**Re: Farm Road Homes Residential Development – Comprehensive Permit
Engineering Peer Review – Traffic
55-65 Farm Road
Sherborn, MA**

Farm Road Homes Residential Development
Engineering Peer Review - Traffic
55-65 Farm Road
January 16, 2024 Review Letter

Figure 8B-6. Example of Placement of Warning Signs and Pavement Markings at Grade Crossings
Manual on Uniform Traffic Control Devices (MUTCD); Federal Highway Administration; Washington, D.C.; 2009.

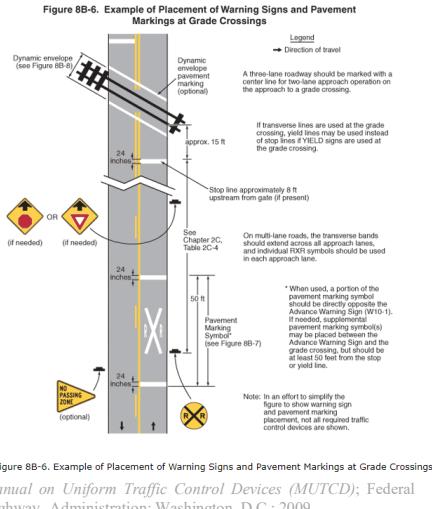
An inventory of the traffic control devices at the at-grade railroad crossings of Route 27 and Farm Road was completed in October 2023. Based on this inventory, the following recommendations are offered and should be considered independent of the Project:

Route 27 Crossing

- Refresh the stop-line and RXR pavement markings with high visibility thermoplastic markings.

- Relocate/install railroad crossing warning signs (W10-1) opposite the leading edge of the RXR pavement markings and positioned 100 feet from the centerline of the stop-line on the approach to the rail crossing.
- Consider installing a side street rail crossing warning sign (W10-4) for motorists exiting the south driveway that serves 19 North Main Street.

- **VAI 12/12/23 Response:** *Subject to receipt of all necessary rights permits and approvals, the Applicant will design and construct the following improvements at the Farm Road crossing as recommended in the October 18, 2023 response letter:*

- Refresh the stop-line and RXR pavement markings with high visibility thermoplastic markings.
 - Relocate/install railroad crossing warning signs (W10-1) opposite the leading edge of the RXR pavement markings and positioned 100 feet from the centerline of the stop-line on the approach to the rail crossing.

- **TT 1/16/24 Update:** **Tetra Tech recommends a Condition requiring the Applicant complete the off-site improvements noted in the Applicant's December 12, 2023 response at the existing at-grade rail crossing on Farm Road. The Condition shall also note that all improvements shall be reviewed and approved by the Sherborn DPW prior to implementation.**
